CONNECTION ASSESSMENT & APPROVAL PROCESS

*Project: Installation of a 2nd 125MVar 128kV Capacitor Bank
at Leaside TS*

CAA ID No. 2003-EX141

Date: 14th August 2003

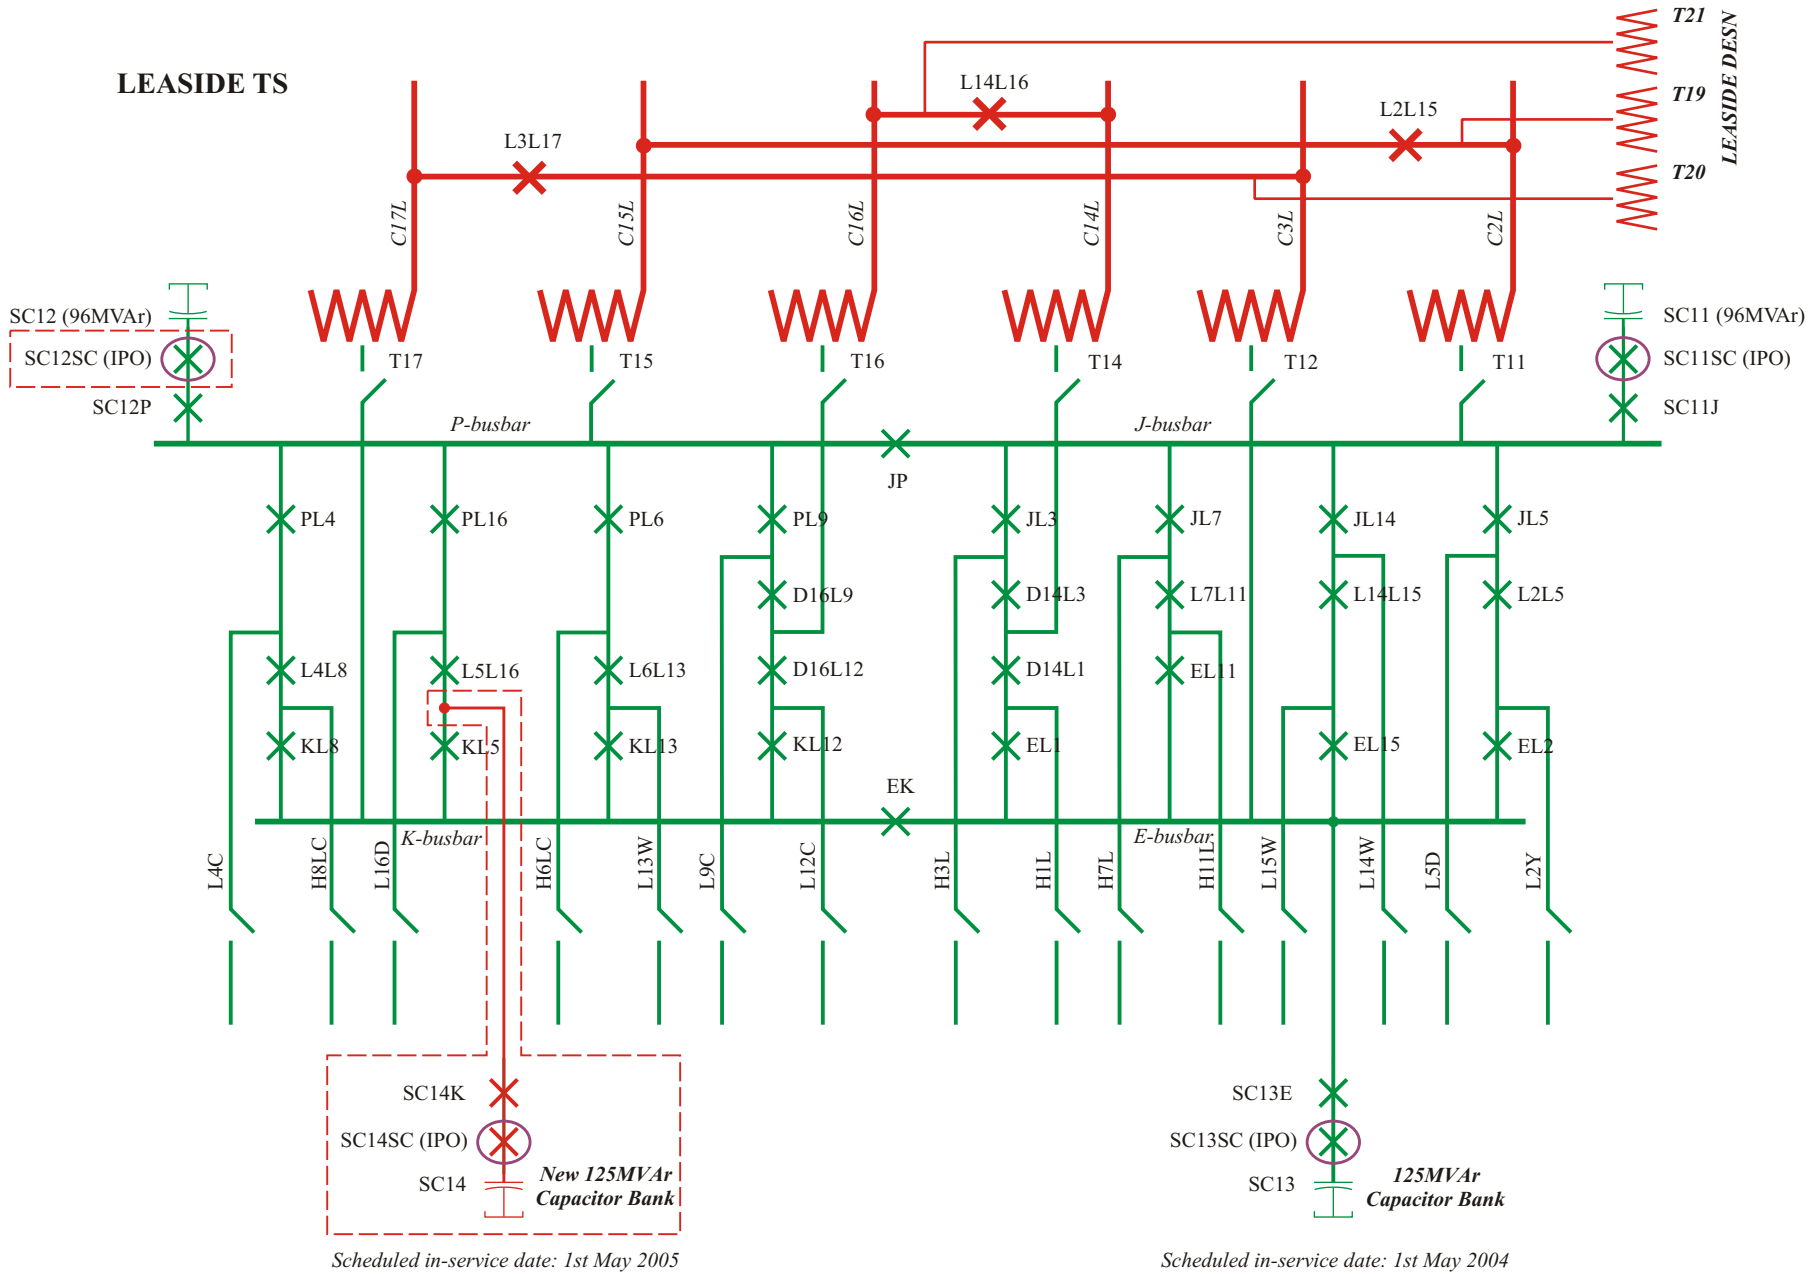
The new capacitor bank, SC14, rated at 125MVAr 128kV is to be connected to the idle position between the existing 115kV breakers L5L16 & KL5 at Leaside TS, through two series-connected breakers as shown in Diagram 1.

The proposed connection of the second 125MVar capacitor bank to the idle position between breakers L5L16 & KL5 instead of a connection to the *K* busbar at Leaside TS would avoid similar problems to those associated with the location of the other three 115kV capacitor banks at Leaside TS.

The proposed connection arrangement is therefore acceptable to the IMO.

DIAGRAM 2

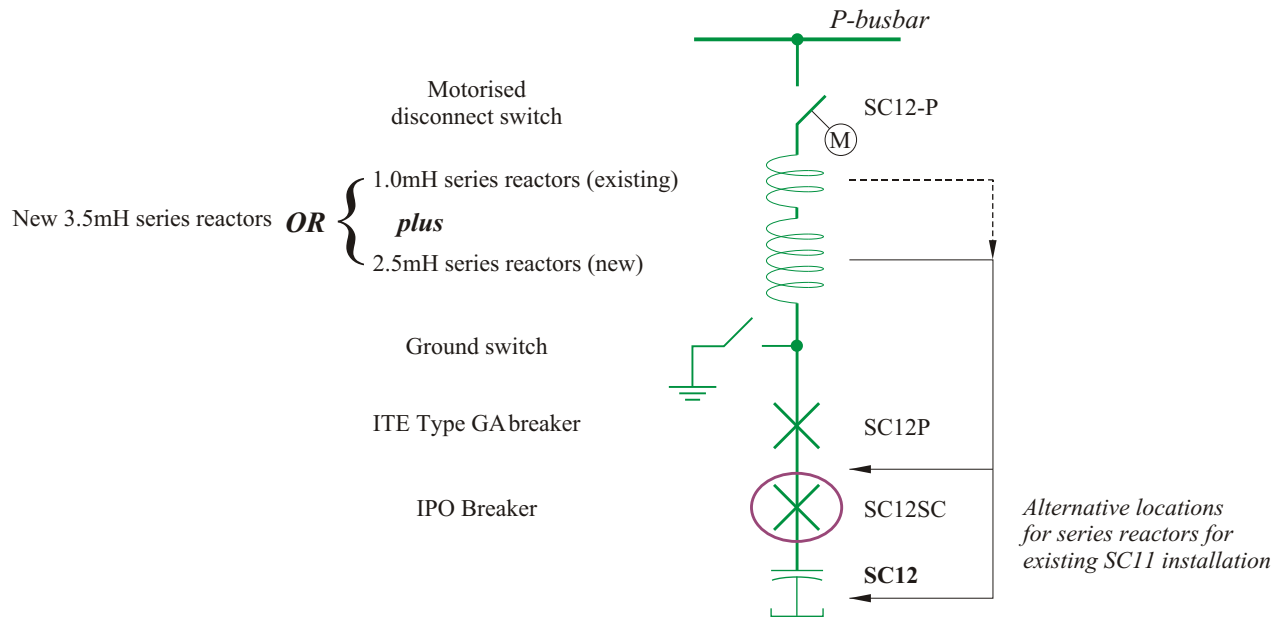
Series reactors rated at 3.5mH are to be installed on the new capacitor bank to limit the out-rush current from the individual capacitor banks due to close-in faults at Leaside TS. These are to be installed between the disconnect switch and the back-up breaker, as shown in Diagram 2.

The existing SC12 capacitor bank is already equipped with 1.0mH series reactors. These are either to be replaced with new 3.5mH series reactors or additional, complementary 2.5mH reactors are to be installed to provide a combined reactance of 3.5mH. The preferred location for the new 2.5mH or the replacement 3.5mH series reactors is between the disconnect switch and the back-up breaker. However, should space constraints preclude their installation in this location, then the preferred alternative would be between the two breakers.

In the event that the series reactors cannot be located at either of the positions above, then they would need to be installed either between the IPO Breaker and the SC12 capacitor bank, or in its neutral connection.

Each capacitor bank is to be equipped with surge arresters and these are to be located between the IPO breaker and the actual capacitor bank.

The new capacitor bank is to be connected to the idle position on the 115kV busbar at Leaside TS through a motor-operated disconnect switch, as shown in Diagram 2.
